Access Compliance Report

Public Rights-of-Way

(Pedestrian Signals)

Intersection ID: N/A	Main Street:	Cross Street: N/A	Location: N/A
ADA ID: 3B106DA2593D	Signal Type: Two Push Buttons-APS	Overall Compliance: No	Severity Score: BTN 1:N/A BTN 2: N/A No BTN: N/A
Codes/Mitigation Info/Possible Solution		Field Measurements/Component Compliance

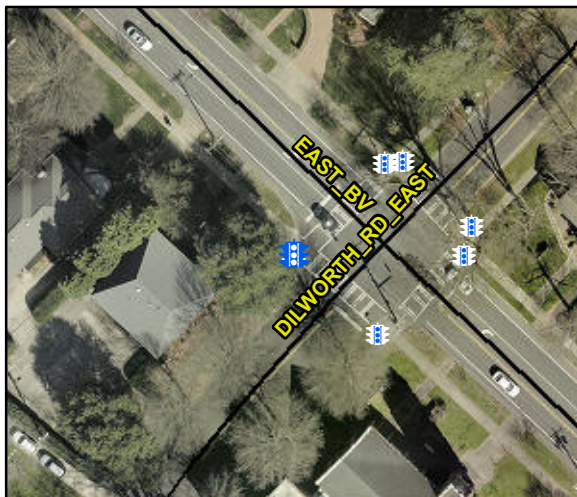
Possible Solutions: Remove & Replace
Replace APS Button With New APS Button.
Remove and Replace Clear Space. Provide
Clear Space.

PROW/ADA: R404.2, R404.3, R406.2,
R404.7.3, , R404.7.1, R404.7.2
